# HUSQVARNA TECHNICAL BULLETIN HTB2508 – USA

**RECALL: THIS MODIFICATION HAS TOP PRIORITY AND MUST BE PERFORMED IMMEDIATELY TO ENSURE CUSTOMER SAFETY**

## SOFTWARE UPDATE ENGINE CONTROL UNIT

**2024 SVARTPILEN 401**

Fig. 1: Connection diagram for XC\_2

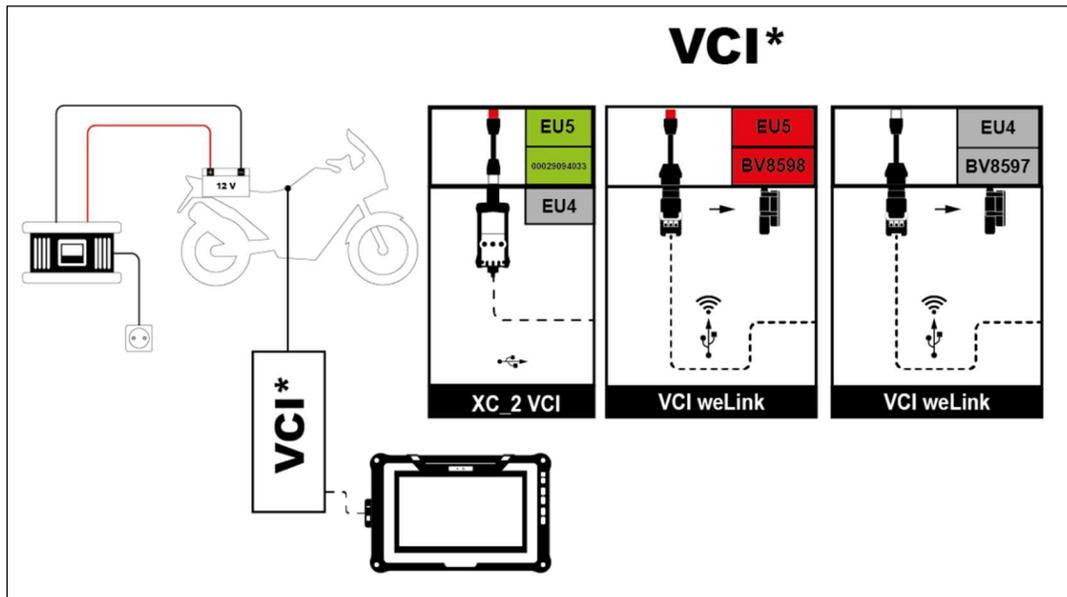
- Connect vehicle to the diagnostic tool and external voltage supply (XCharge) as shown in Figure XC\_2.
